MEMORANDUM

TO: Heritage Markham Committee

SUBJECT: Site Plan Control Application
Proposed Addition to an Existing Heritage Dwelling
27 Victoria Ave., Unionville Heritage Conservation District
SPC 22 111838

Proposed Elevations

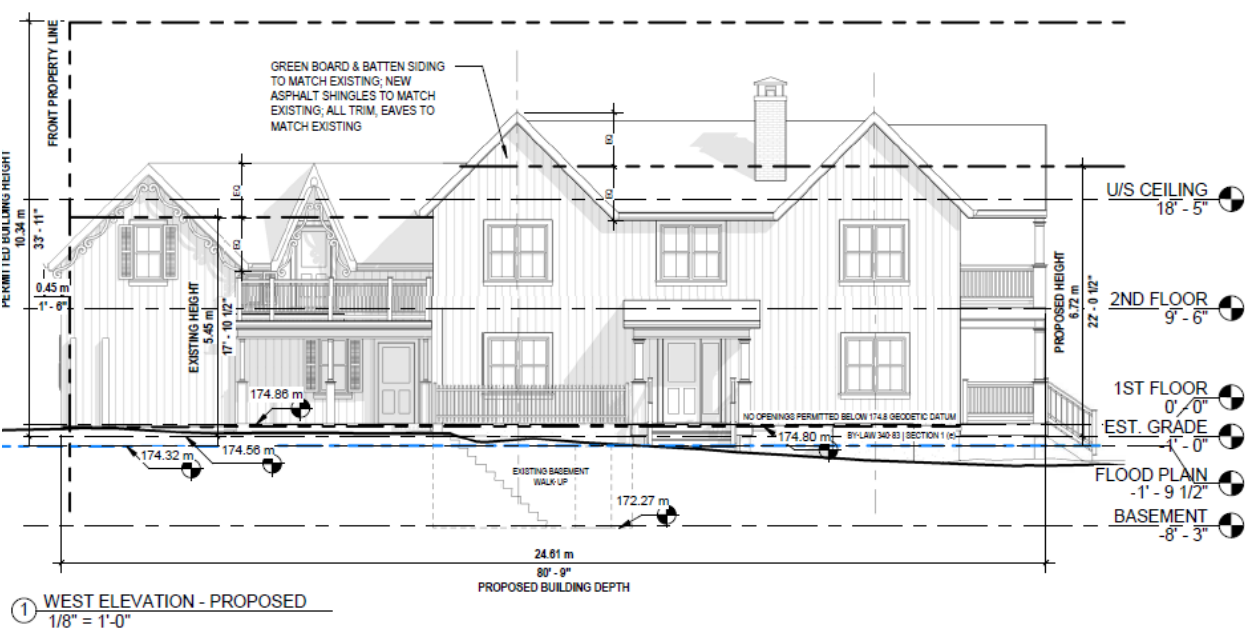
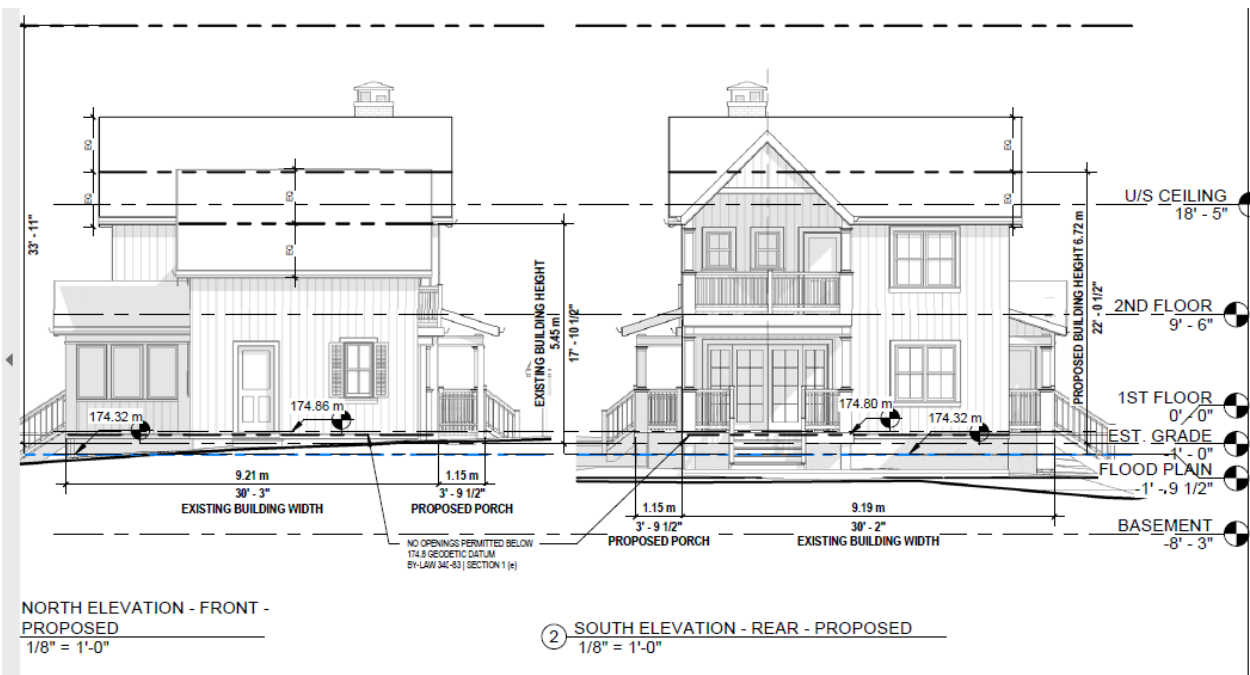
- However, staff recommends that the height of the proposed addition be lowered by at least 2 ft. to make it more in scale with the existing heritage dwelling, and that volume of the second floor rooms be captured within the proposed roof structure, as per the guidelines contained in the Unionville Heritage Conservation District Plan regarding addition to heritage buildings; (See attached guidelines);

- Given that there is an existing, historic second floor door on the west facing gable of the rear tail of the heritage portion of the house, Staff supports the creation of a small balcony within the slope of the existing veranda, rather than a full balcony on new posts (as proposed), in order to limit the amount of railing visible looking east on Victoria Ave., Railings conforming to the standards of the current Ontario Building Code are not

considered to be aesthetically compatible with historic homes, and this view of the dwelling is the most significant public view. The proposed veranda treatment would also see the removal of the historic veranda posts and replaced with a non-traditional post- this should not be supported;

- Staff also notes that a skylight has been proposed for the east slope of the tail of the heritage portion of the house. Although skylights are not considered appropriate for historic roofs or roofs visible from the public realm, staff acknowledges that this may be the preferred solution to provide some daylight to a bedroom that will have its original southward facing window(s) blocked by the proposed new addition. A flat profile skylight with glazing in a dark colour would likely be preferable to the construction of a more traditional dormer, as a new dormer would be a more significant alteration of an original roofline which would create visual clutter given the form of the proposed addition.

- A non-traditional entrance treatment has been introduced on the west elevation (new addition) with a single sidelight. However, given its location (setback) and visibility, staff had not requested revision.

- THAT the height of the proposed two storey addition be reduced by a minimum of 2 ft. to make the addition more in scale with the existing heritage dwelling and that the volumes of the proposed second floor rooms be contained within the roof structure;
- THAT notwithstanding the policies contained in the Unionville Heritage Conservation District Plan regarding skylights, Heritage Markham has no objection to the proposed skylight on the east facing slope of the rear tail of the heritage portion of the house provided it is flat in profile and of a glazing that closely matches the colour of the roof;
- THAT Heritage Markham does not support the proposed new veranda and balcony on the west side of the rear tail of the heritage portion of the house, but would support a smaller balcony within the existing veranda roof utilizing the existing turned porch posts;
